PCN: V18-003-F48070-MA

Product Change Notice

Qualify NiPdAu pre-plated lead-frame.

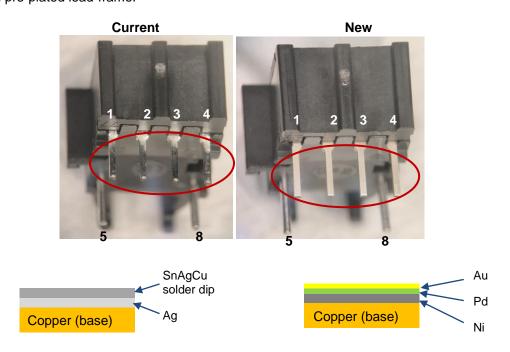
Active pins (pin1 to pin4 in red circle): Affected by changing to new NiPdAu lead-frame finish.

Housing staple pins (pin5 and pin8): No Change.
